Orchards at Grand Teton & Teton - units 2 & 3

PROJECT: (update to DS 4558 & DS 4274)

SUBMITTAL: 2nd

CITY OF LAS VEGAS		DATE:
INTER-OFFICE MEMORANDUM		October 18, 2012
TO: Land Development Services Department of Public Works		FROM: Albert Sung, P.E. Flood Control Project Engineer Department of Public Works
SUBJECT: Drainage Study for: Orchards at Grand Teton & Tenaya – Units 2 & 3 (Update to DS4558 & DS4274)		COPIES TO: Taney Engineering
Cross Streets:	SWC of Grand Teton Blvd. & Tenaya Way	D.R. Horton
File Number:	F:\Depot\DSMemos\DS4569B.doc	Bart Anderson, P.E., DevCo
Parcel Number:	125-15-101-003	CCRFC
Zoning Action:	TMP-45536	CCPW
FEMA Flood Zone	YES	NO X
Proposed Storm Drain	YES	NO X

Unit 3

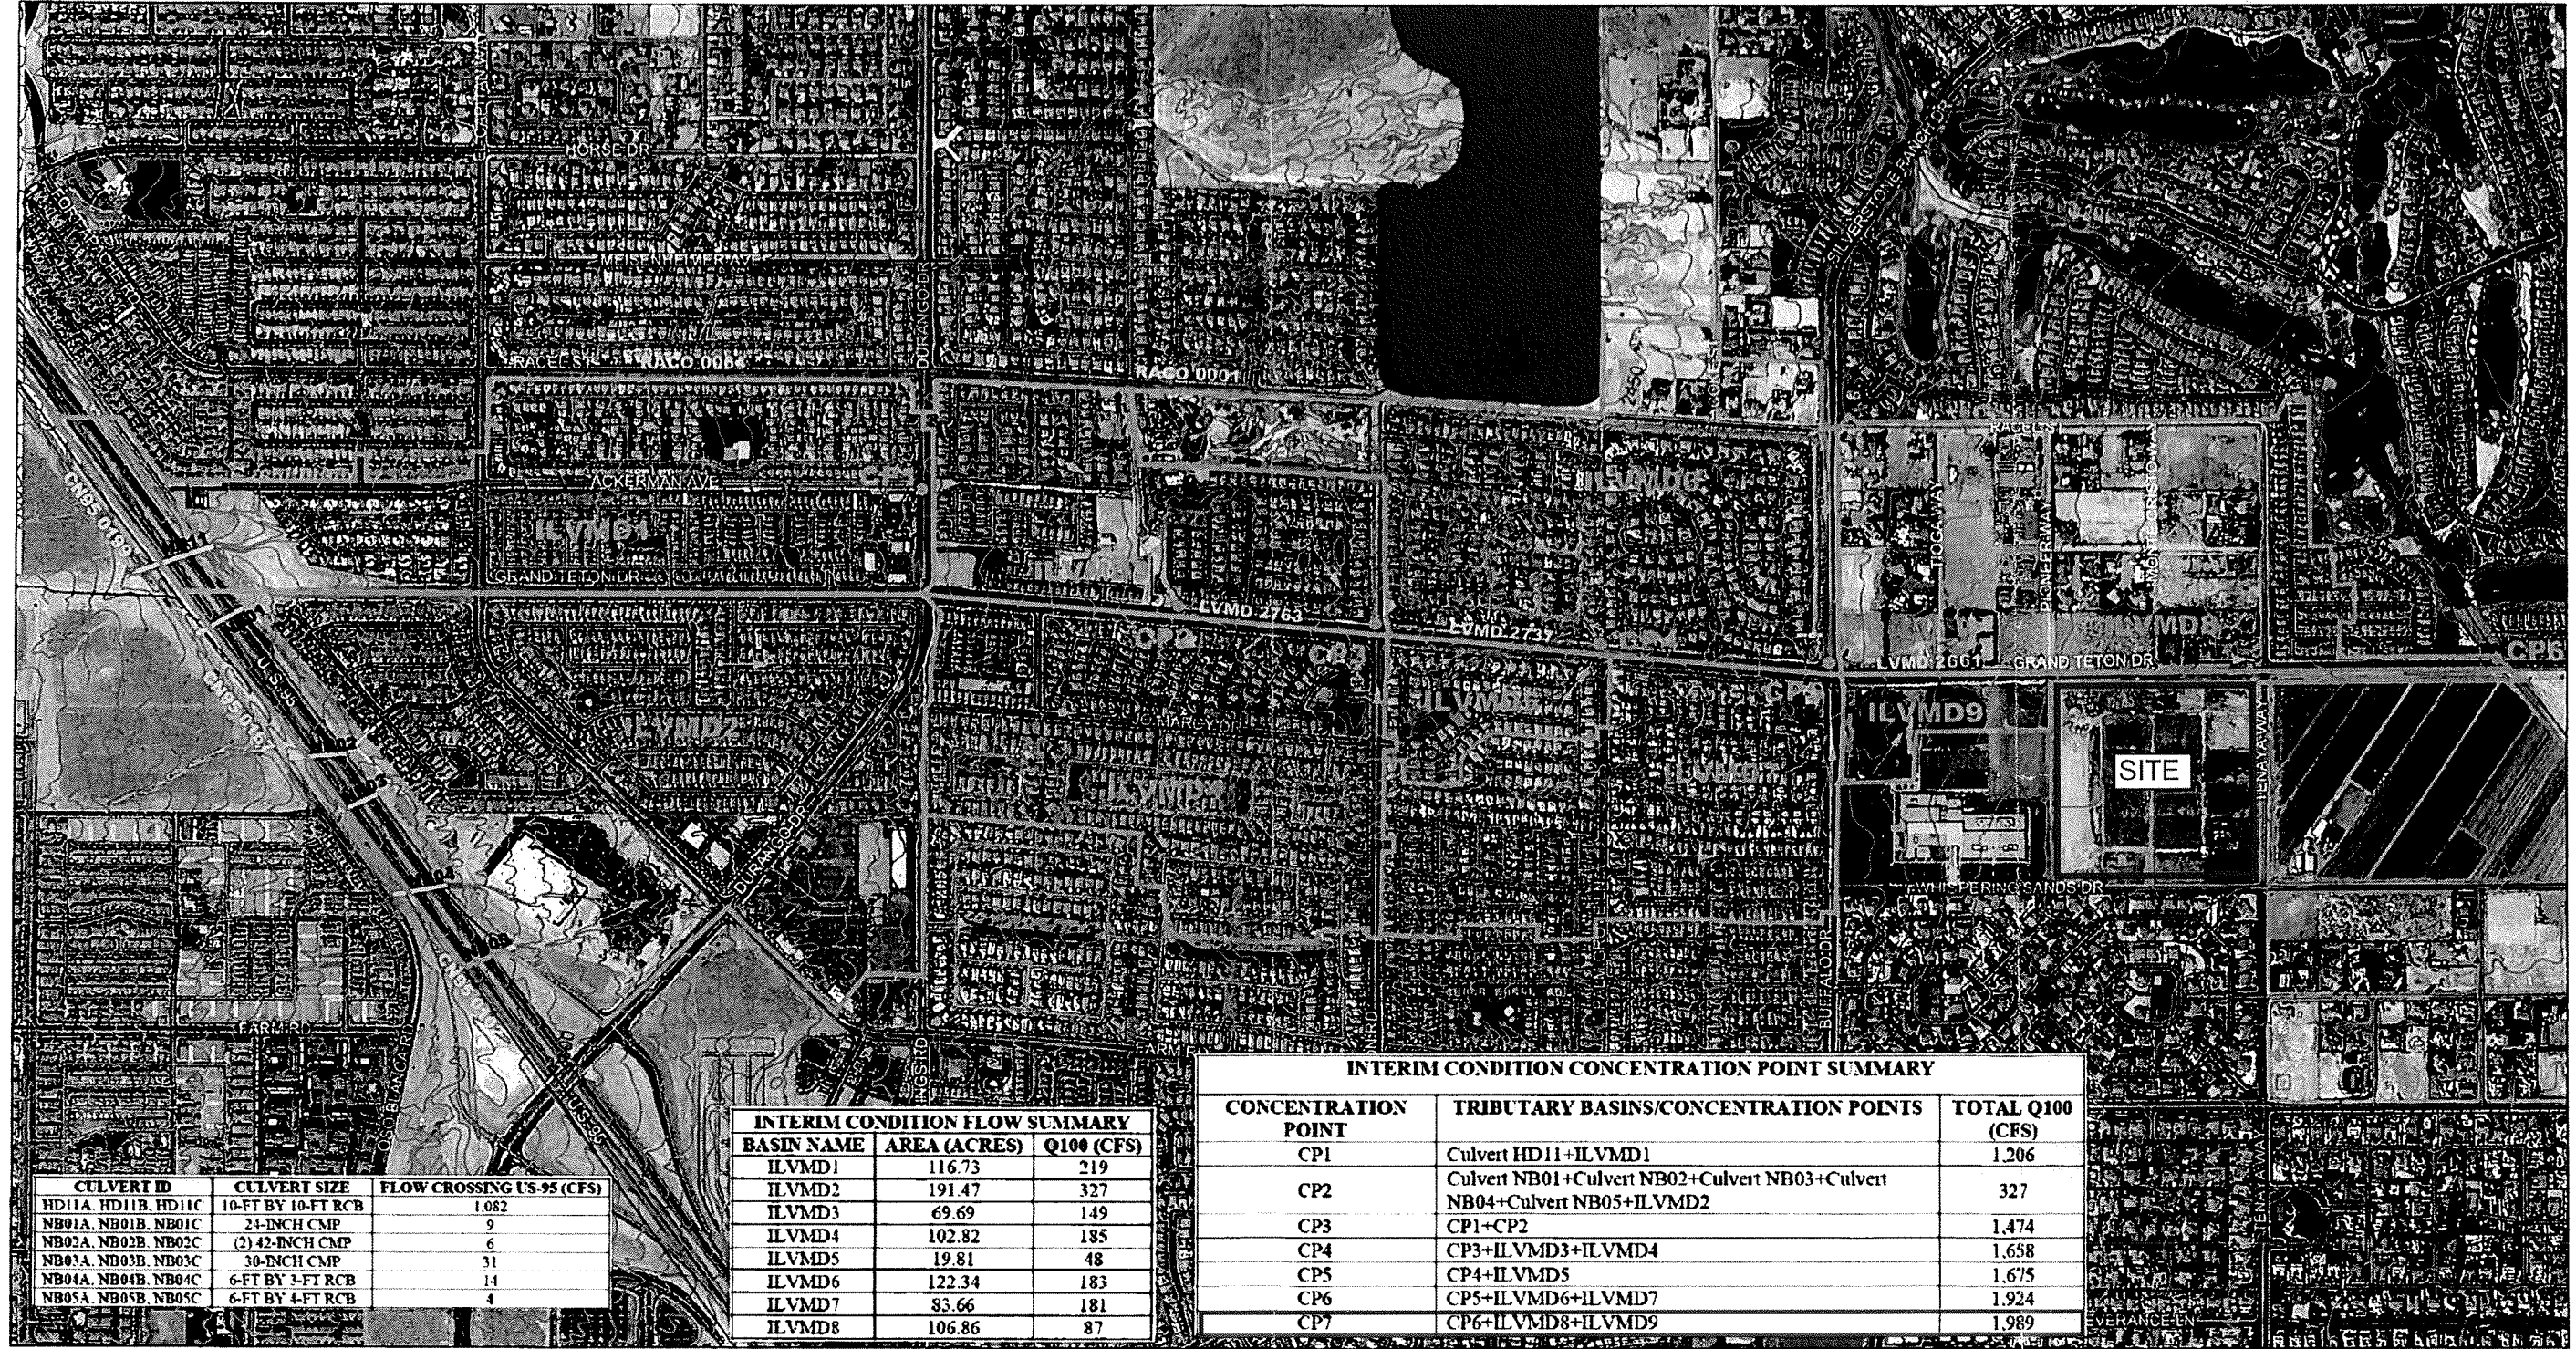
~~The provide HEC-RAS analysis shows that the interim flow depth in Grand Teton is above the proposed First Floor Elevations (FFE's). Manual requirements require FFE's to be twice the depth of flow up to 18-inches. Raise Pad & FFE's along Grand Teton to comply with manual requirements.~~

~~Flood Control still requires that the adjacent boundary wall along Grand Teton be solid grouted 18" above the W.S.E.~~

STORM DRAIN PLAN AND PROFILE
 "SD1" 78+00 TO "SD1" 86+50
 LAS VEGAS WASH MIDDLE BRANCH
 GRAND TETON STORM DRAIN
 DURANGO DR. TO RAINBOW BLVD.

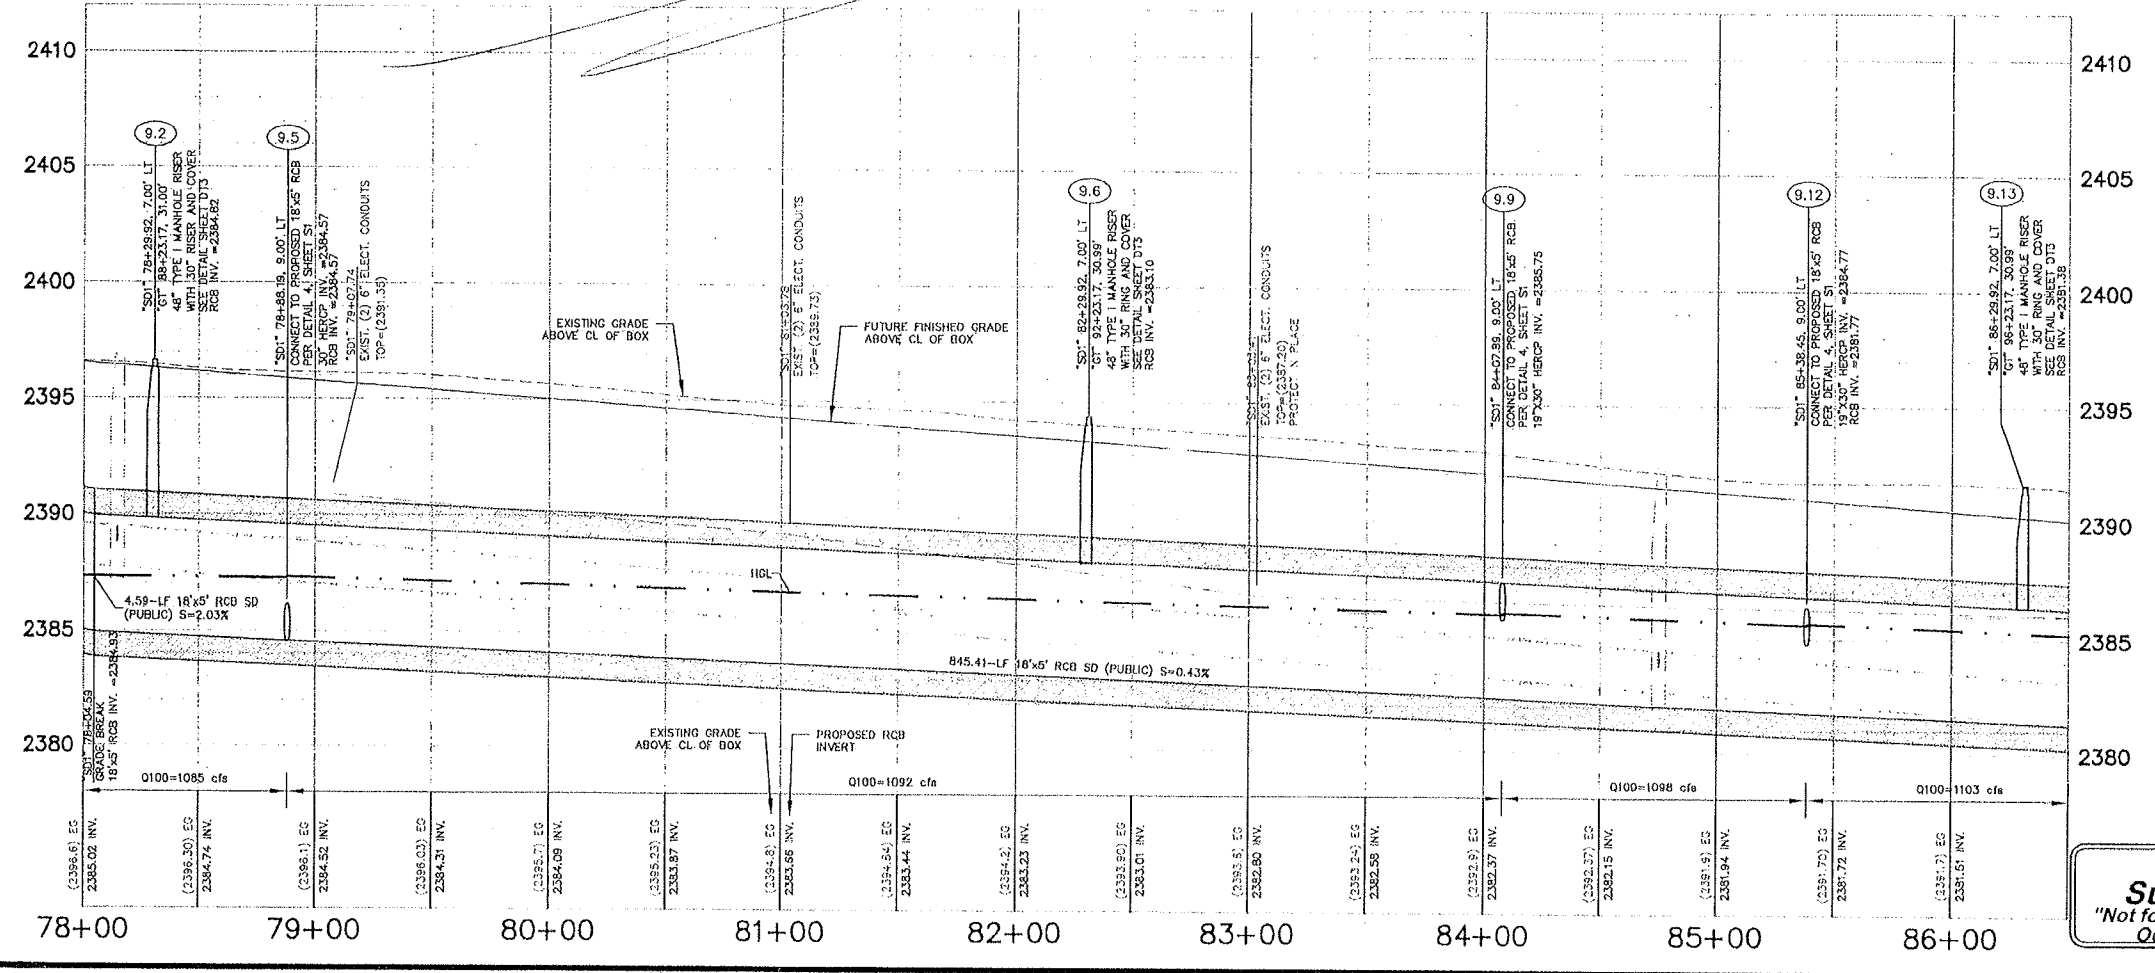
As discussed @ walk-thru
Add inlet @ End of School pick-up w/ Inlet
Drainage from School

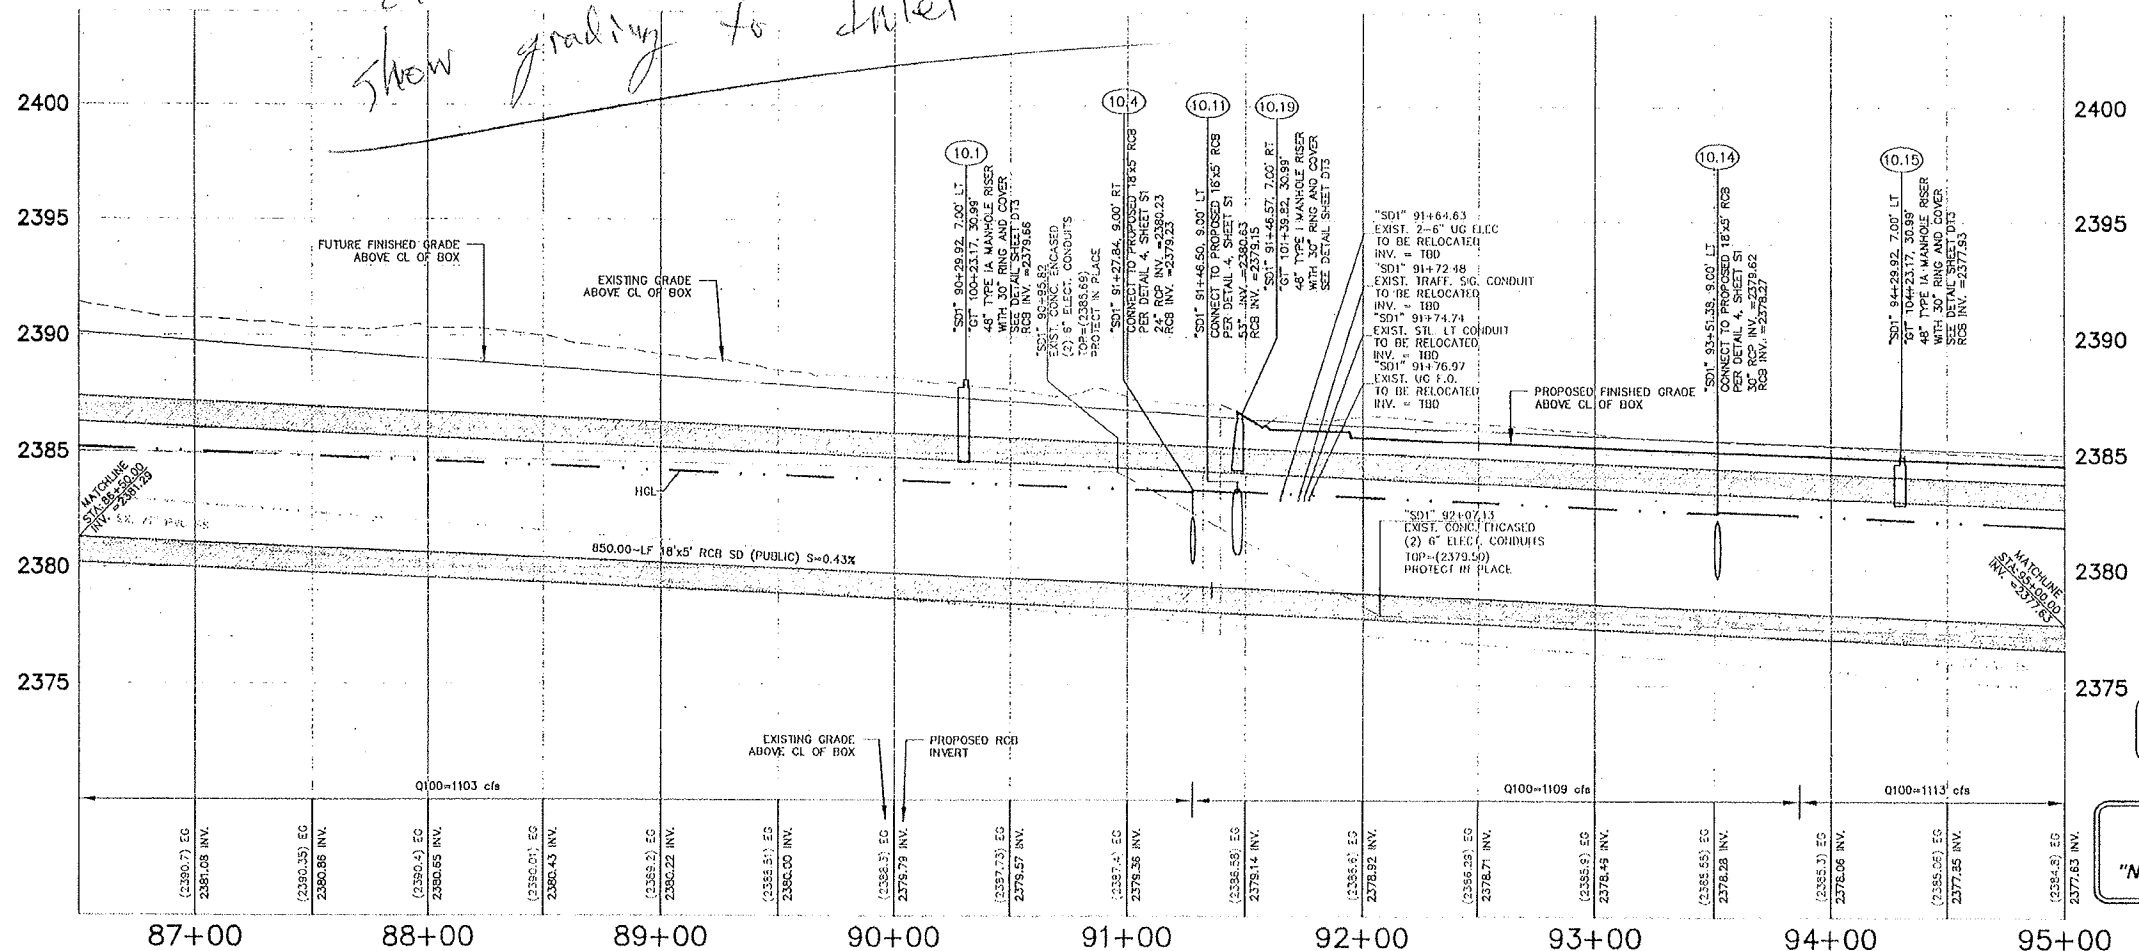
*UG is @ low point
Extend grading south to
show grading to Inlet*
